Bureau of Engineering
Report No. 1

August 13, 2014
CD No. 4

APPROVE A CLASS "B" PERMIT FOR VOLUNTARY NON-STANDARD IMPROVEMENTS ON BULWER DRIVE

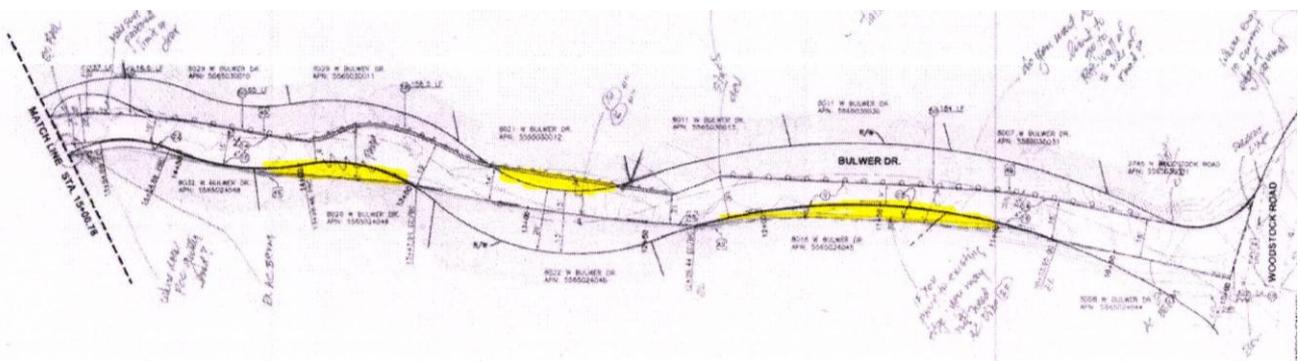
The BOE recommends that a slurry trench/cut-off wall be constructed along the outer edge of the compacted fill. This small cut-off wall will prevent rodents from mining underneath the roadway. Such rodent paths potentially become a conduit for water which can lead to erosion and a washout of the roadway.

The BOE recommends that a drainage system be constructed to provide relief to any area impoundments and convey the water to the existing storm drain system. In the event that slough and debris from slope failures above the roadway block water flow on the roadway surface to the storm drain system, an alternate path of travel for the water is provided. Small pipes and basins will provide a means to collect water from any impoundments and convey it to the existing system.

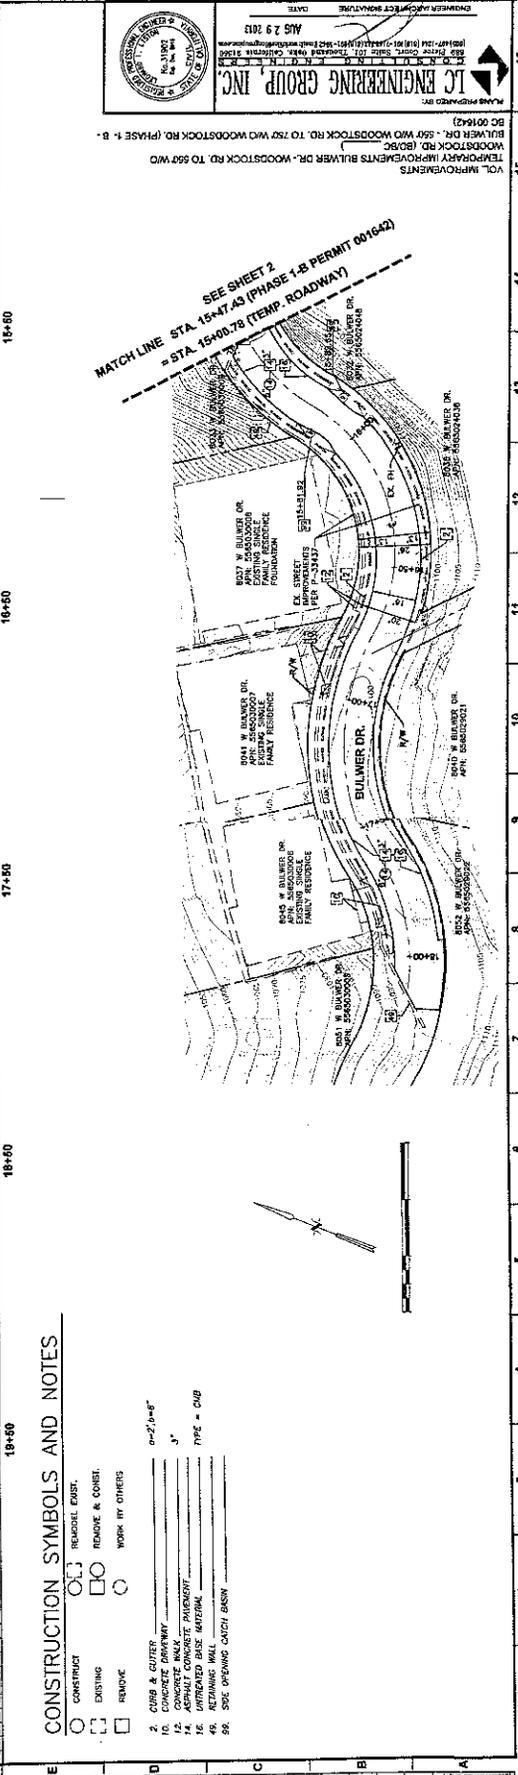
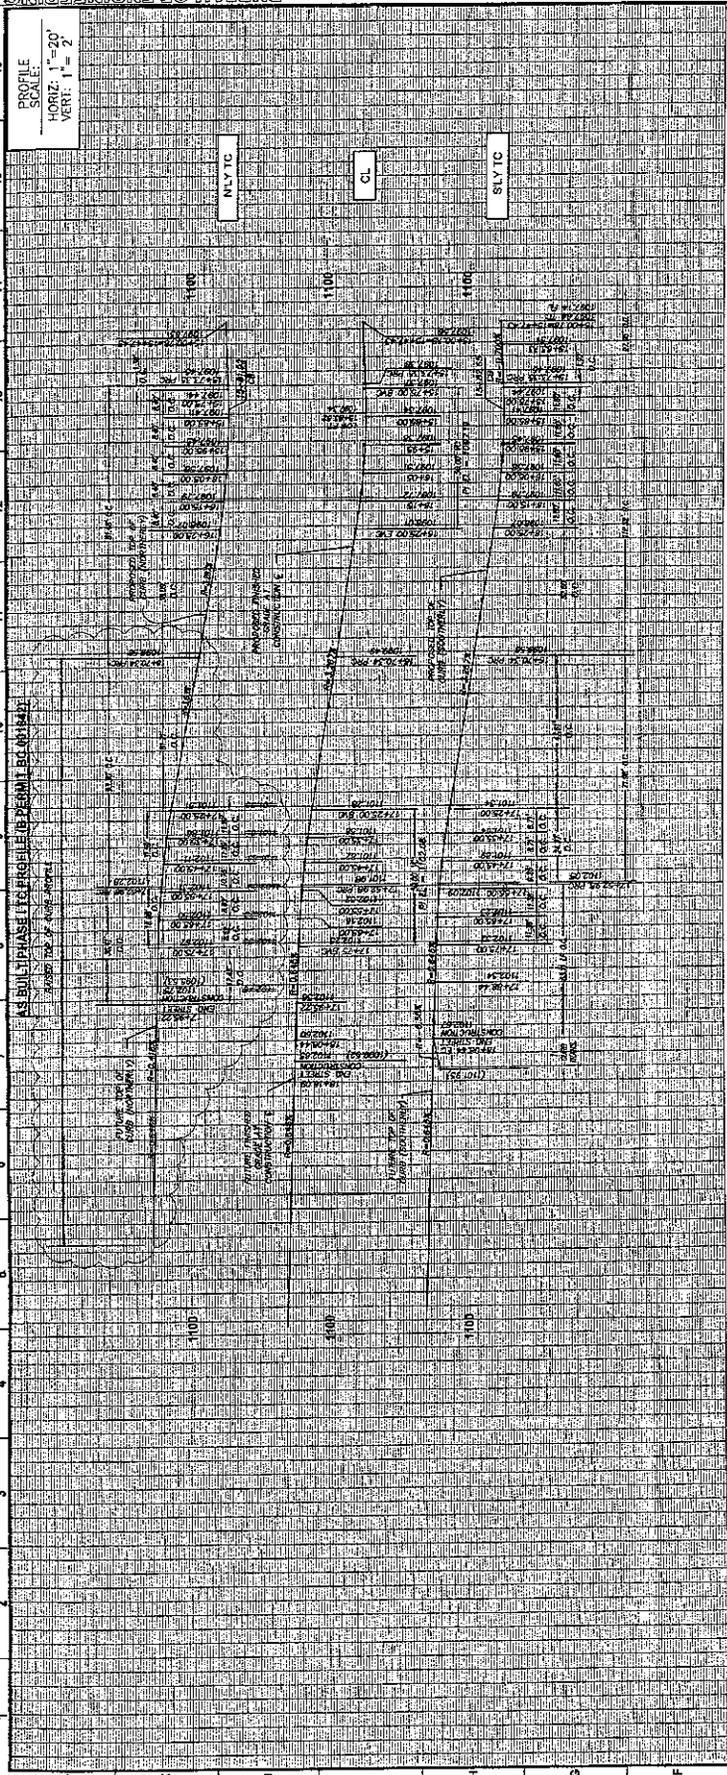
The above referenced three-sheet plan for the road indicates that the existing dirt road is only partially within the City Right-of-Way (ROW). After making site visits and reviewing the plans, it is apparent that it is impractical to construct an improved roadway of 9 ft or greater width within the

GEO has made site visits and reviewed the listed documents in regard to the overall proposed paving and concluded that it would be beneficial to the drainage and stability of the hillside. The GEO developed a list of concerns that will need to be addressed prior to approving the proposed paving of the street. These basic concerns are presented below. From the plans, it was noted that there is only about 6 feet of fall from Woodstock Drive for a distance of 585 feet; therefore, only a 1% gradient can be achieved. This is relatively flat and in order to ensure ingress and egress and positive drainage, a number of items along the road will need to be addressed in the final plans prior to paving.

2. About 135 to 140 feet west from Woodstock Drive there is a erosion scar on the downslope side of the unpaved road. The near vertical washout has exposed a utility. The proposed plans should specifically address this and any other down-slope concern that could undermine the pavement of the road.

4. On the up-slope side of the road at about 140 feet from Woodstock Drive there is an erosion scar that appears to be a source of the water flowing onto the unpaved road. The nearest catch basin is about 400 feet away. Given the long distance and the relatively flat gradient, it is likely that this ongoing erosion will be a maintenance problem. The pavement plans need to address this and other up-slope drainage, erosion and potential slope failure problems to ensure that soil and water being washed down from ascending slope will not result in drainage problems. Given the above concern, some type of non-erosive drainage system needs to be incorporated into the pavement design plans.

5. At about 230 west from Woodstock Drive there is a driveway leading to the downslope side of the road. The pavement plans need to include a berm, or some other device to prevent water from flowing from the street to the driveway where the only outlet is to continue to flow uncontrolled down the descending slope.
